Questions and Answers – Renovation Works at Public Affairs Section (PAS)
Solicitation # SBG30015Q0983

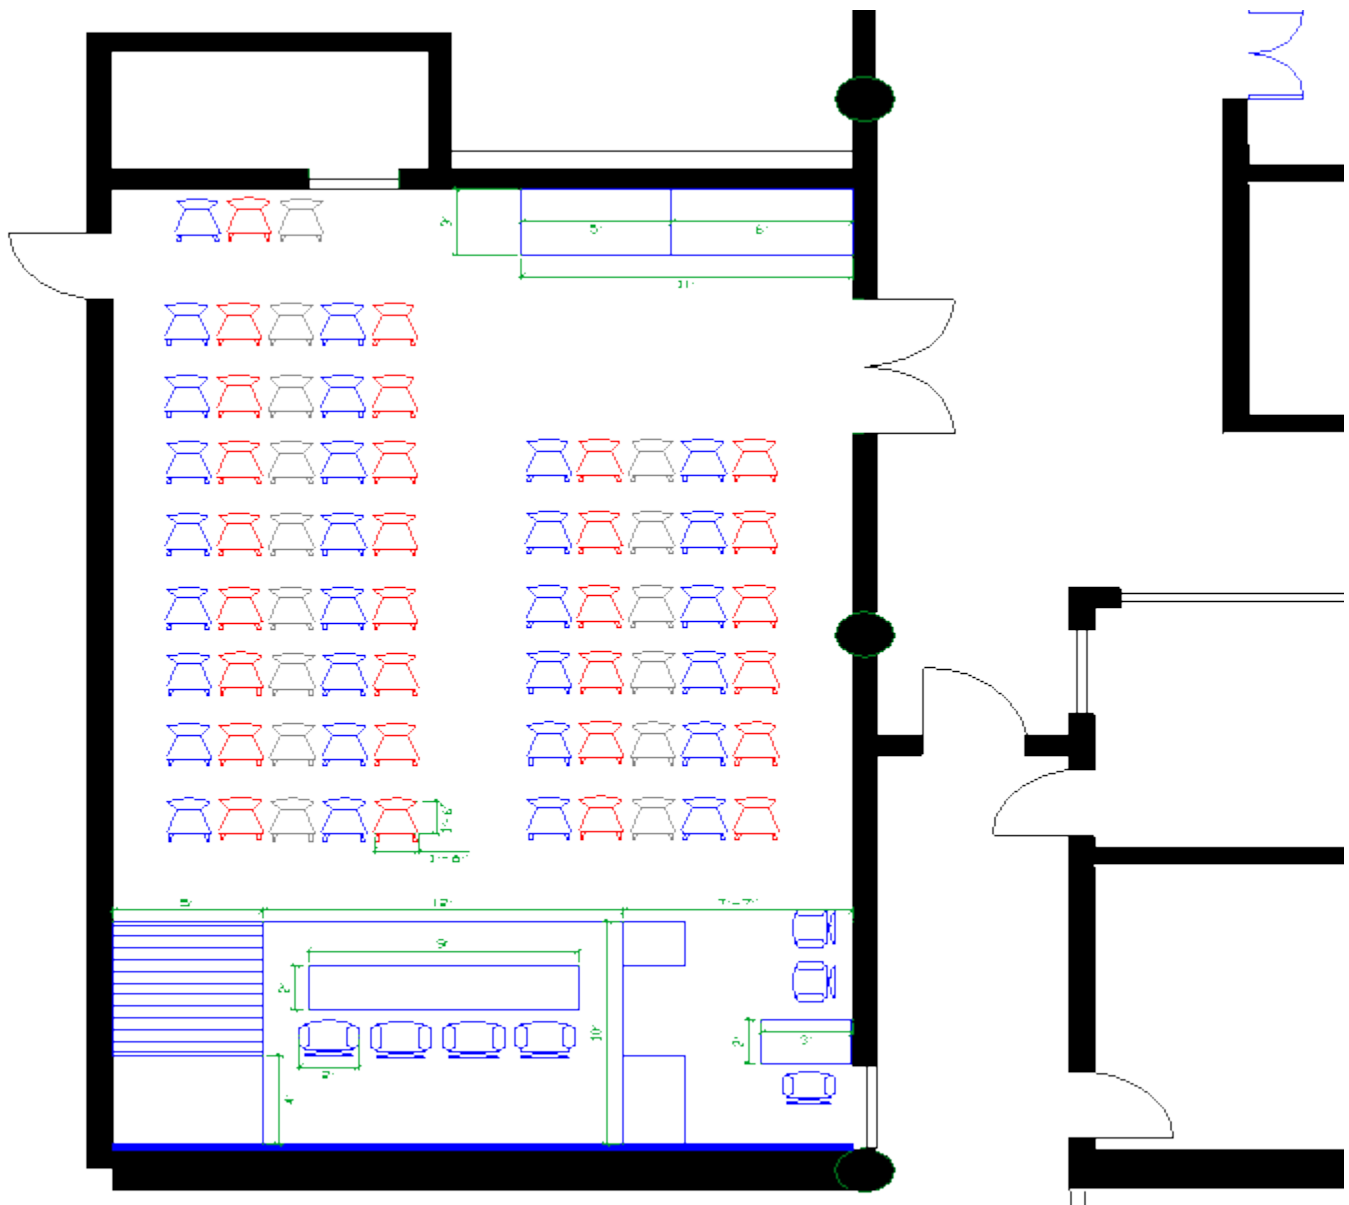
1. As per SOW it is mentioned foldable and movable stage. Which type stage will be needed? please provide us the details Sketch or Drawings.

Please refer to the drawings provided in the bid documents. The stage is 10' x 12'. It will be divided into 2 equal portions. It should be made of 1" thick Burma Teak wood. Support should be provided by 4" x 4" block every 2 feet both ways. The ramp besides the stage shall be 5' wide and a landing 4' x 5' will be at the end of the ramp. The drawing is also provided below for guidance.

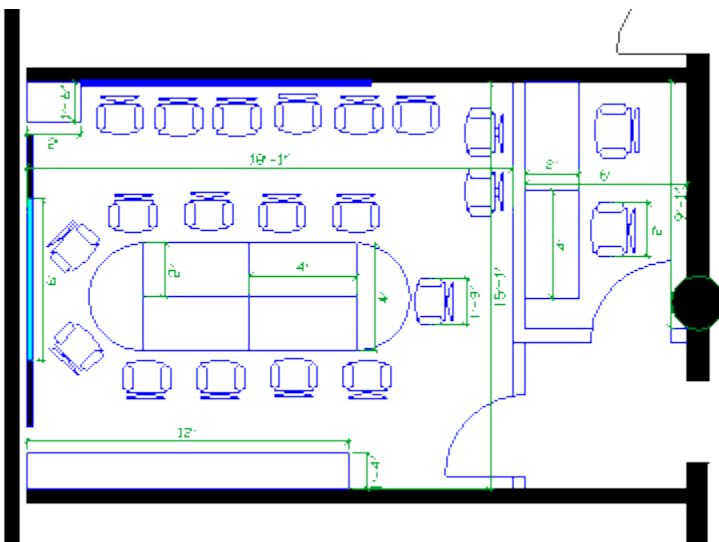
2. **Decorative works at back wall in reception/auditorium area: please provide us the detail description of the work or we need Picture / Sketch / Drawings.**

Please see the design below.
